CITY PLAN COMMISSION STAFF REPORT

Project Name Pacific + Troost

CD-CPC-2022-00006
Area Plan Amendment

CD-CPC-2021-00232

LANDSCAPE PLAN L001

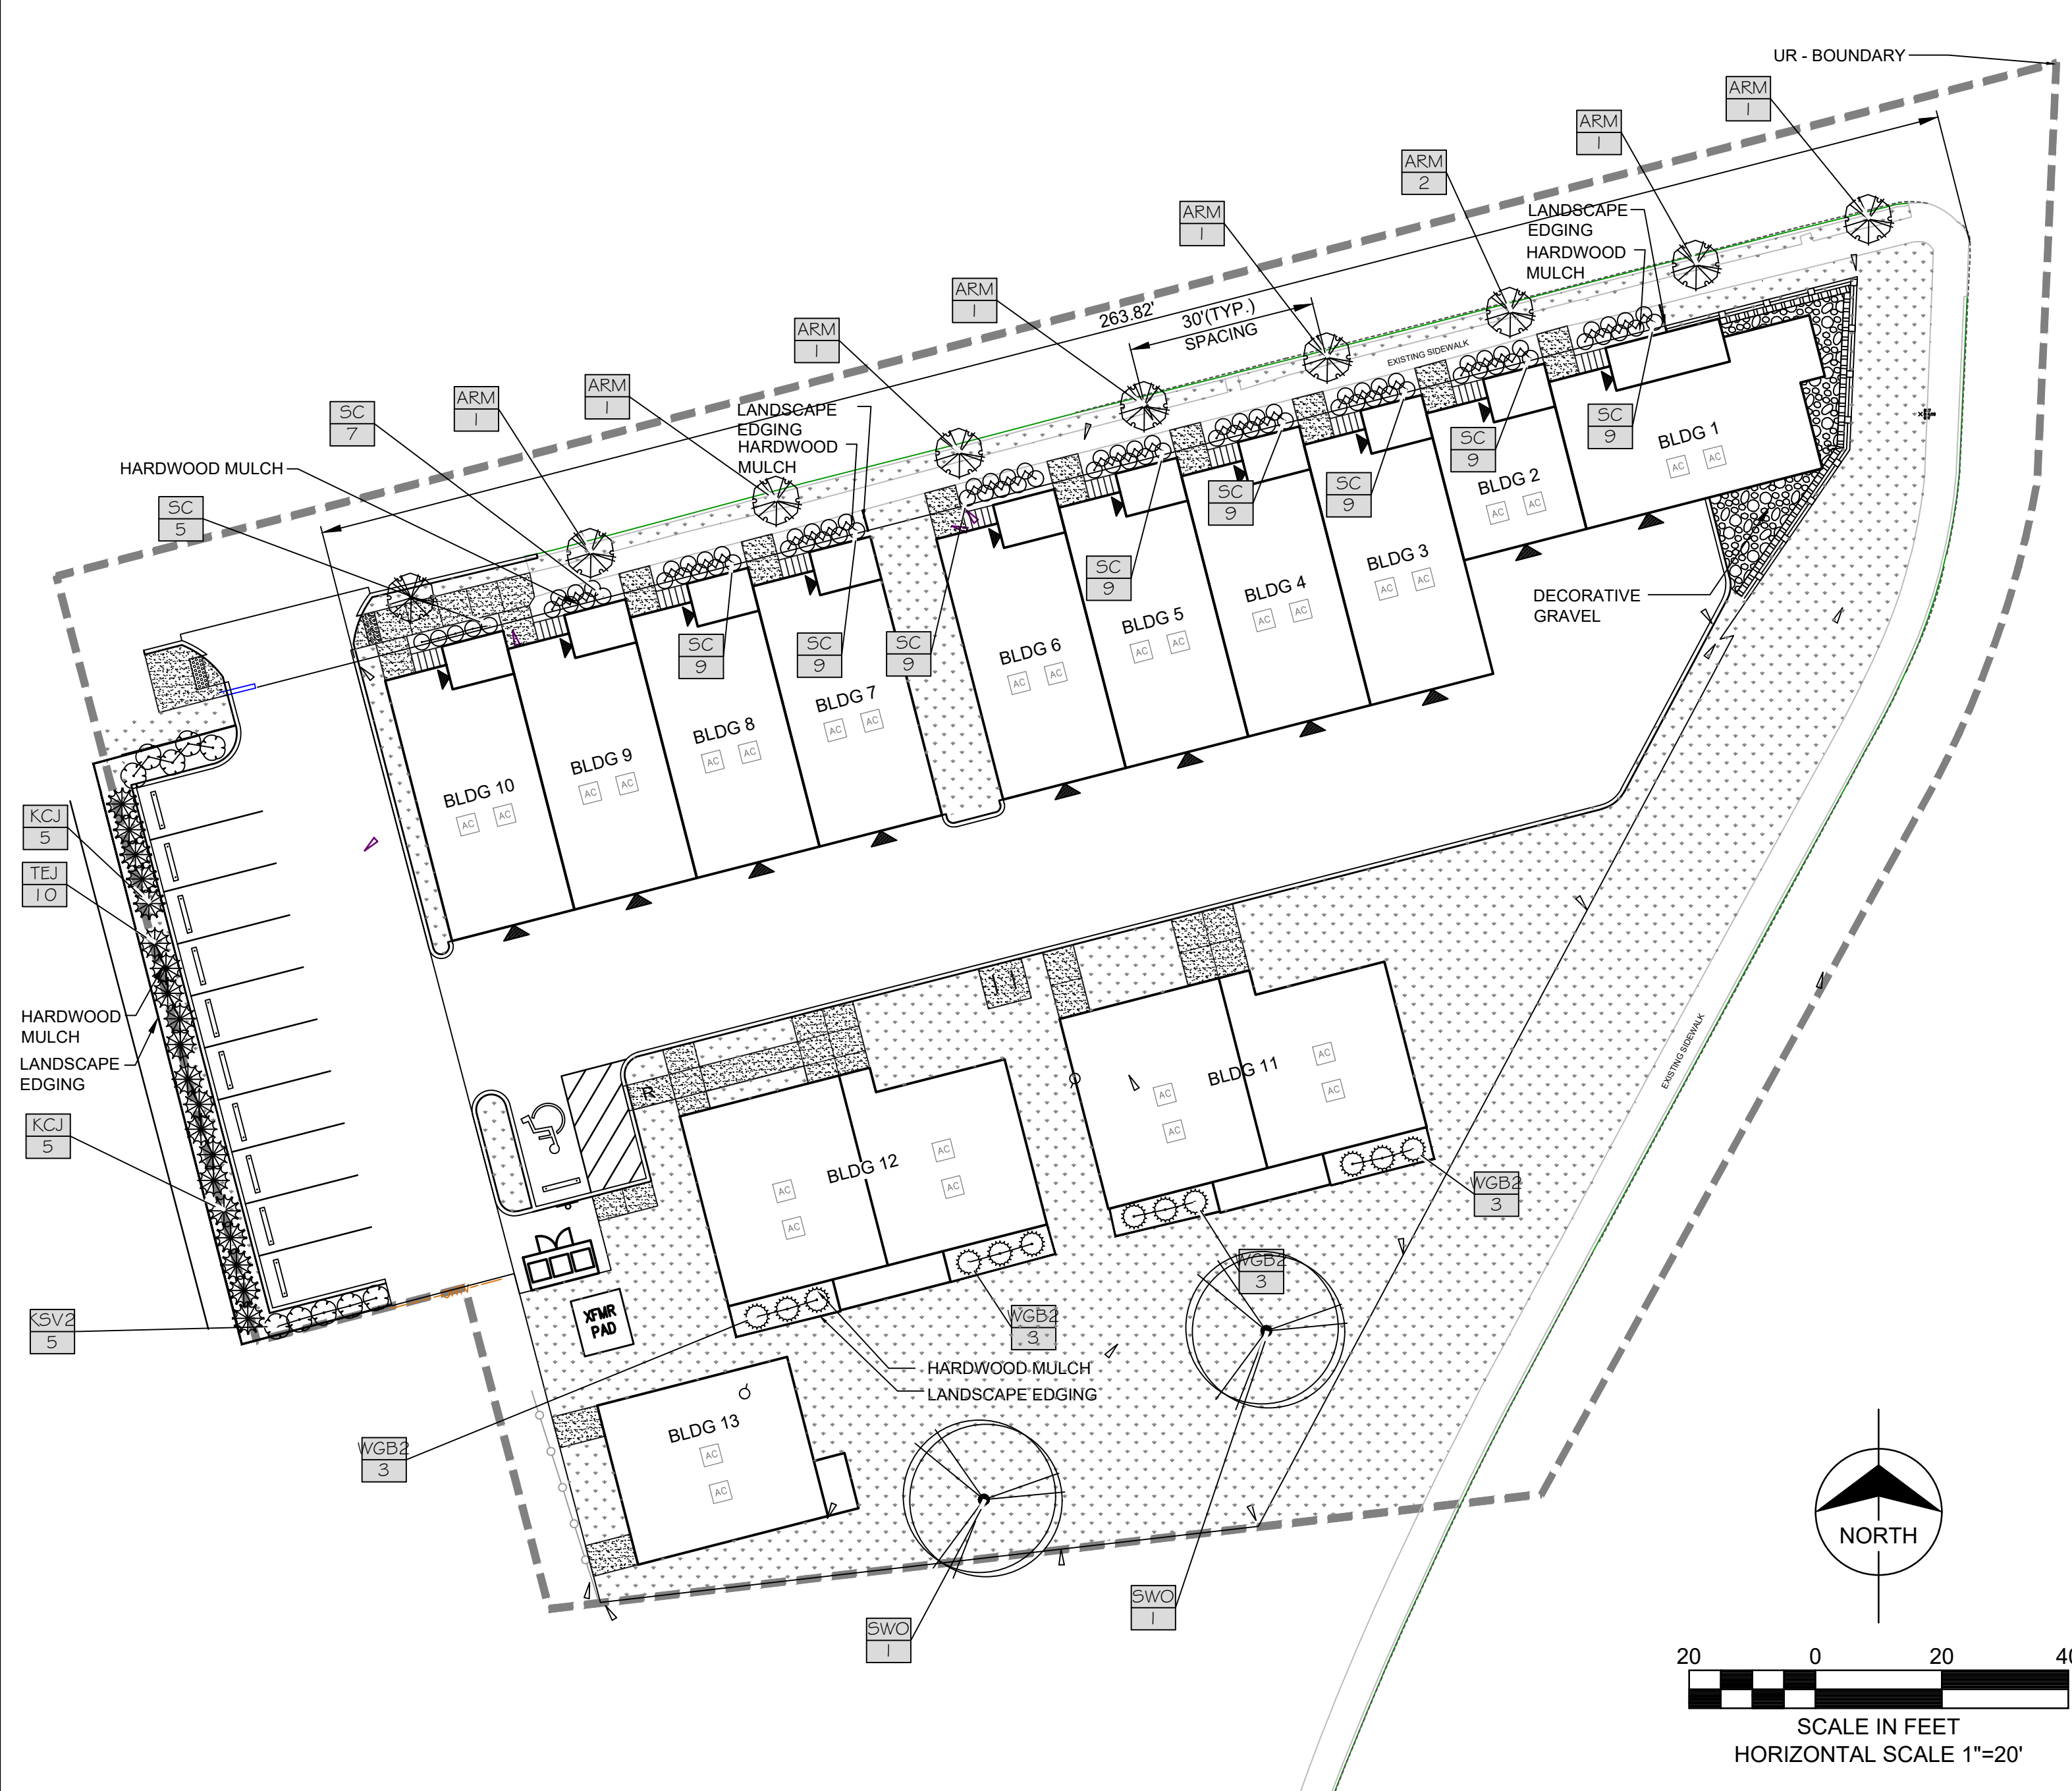
1. To accommodate the owner-occupied townhomes and rental duplexes on-site, a minor subdivision needs to be submitted.
2. Deviations with the associated project 1015 Pacific St (CD-CPC-2021-00232),
 1. Zero-lot lines will be established for the subject site.
3. Adjustments with the associated project 1015 Pacific St (CD-CPC-2021-00232),
 1. Nine (9) street trees plus the ornamental grass feature will be installed on the subject site.

15. The developer shall submit a streetscape plan with street tree planting plan per 88-425-03 for approval and permitting by the Parks & Recreation Department's Forestry Division prior to beginning work in the public right-of-way
16. Money-in-lieu of parkland dedication in the amount of \$15,412.84 shall be paid prior to Certificate of Occupancy.
